# Work Order ID 103790

Item Name: Crosstube Assembly, Mid Fwd

DRAWING NO. D206-667-147	TITLE CROSSTUBE ASS'Y (206L MID FWD)	REV. A	<b>DART AEROSPACE LTD ENGINEERING ORDER</b>		D.E.O. NO. D206-667-147-A-1	SHEET NO. SHEET 1 OF 1	SCALE NTS
DRAWN 90	CHECKED ASS	MFG. APPR. [Signature]	APPROVED [Signature]		DE APPR. [Signature]		
DATE 11.07.15	DATE 11.07.20	DATE 11.07.21	DATE 11/07/21		DATE 11.07.21

DRAWING NO. D206-667-147		TITLE CROSSTUBE ASS'Y (206L MID FWD)		REV. A		DART AEROSPACE LTD ENGINEERING ORDER		D.E.O. NO. D206-667-147-A-2		SHEET NO. SHEET 1 OF 1		SCALE NTS	
DRAWN AJS		CHECKED		MFG. APPR.		APPROVED		DE APPR.		DATE 12.08.02		DATE 12.08.02	
DATE 12.08.02		DATE 12.08.02		DATE 12.08.02		DATE 12.08.02		DATE 12.08.02		DATE 12.08.02		DATE 12.08.02

**DETAIL P**  
BONDING STRAP INSTALLATION 2 PL

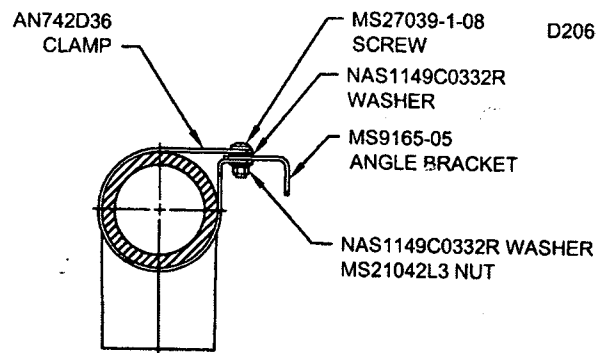
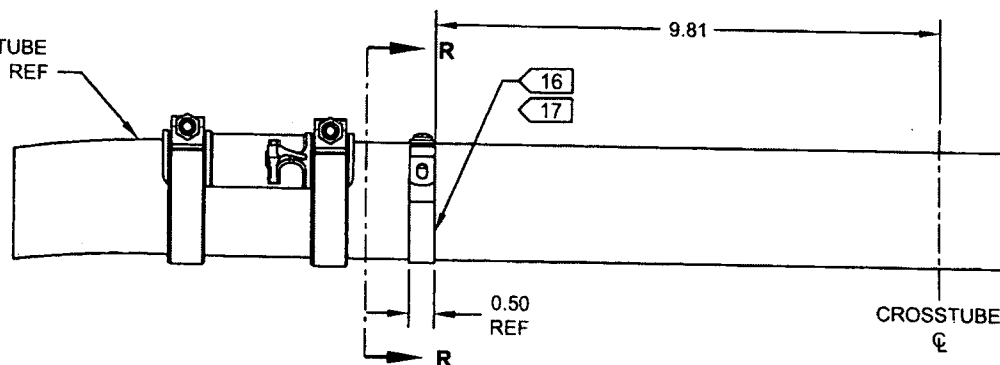
ADD ELECTRICAL GROUNDING STRAP

ITEM	QTY -147	PART NUMBER	DESCRIPTION
1	X	D206-667-147	CROSSTUBE ASSEMBLY (206L MID FWD)
10	2	AN742D36	CLAMP
11	2	MS9165-05	ANGLE BRACKET
12	2	MS21042L3	NUT (OR MS21042-3)
13	2	MS27039-1-08	SCREW
14	4	NAS1149C0332R	WASHER (OR AN960C10L)

- 16) MASK AREA UNDER CLAMP PRIOR TO PAINTING
- 17) SEAL EDGES WHERE AN742D36 CLAMP MEETS WITH THE CROSSTUBE USING SIKAFLEX-241/-291 OR MIL-S-8802 CLASS B2 OR PROSEAL 890 SEALANT
- 18) PERFORM RESISTANCE CHECK TO ENSURE MAX RESISTANCE IS 10 MILLIOHMS
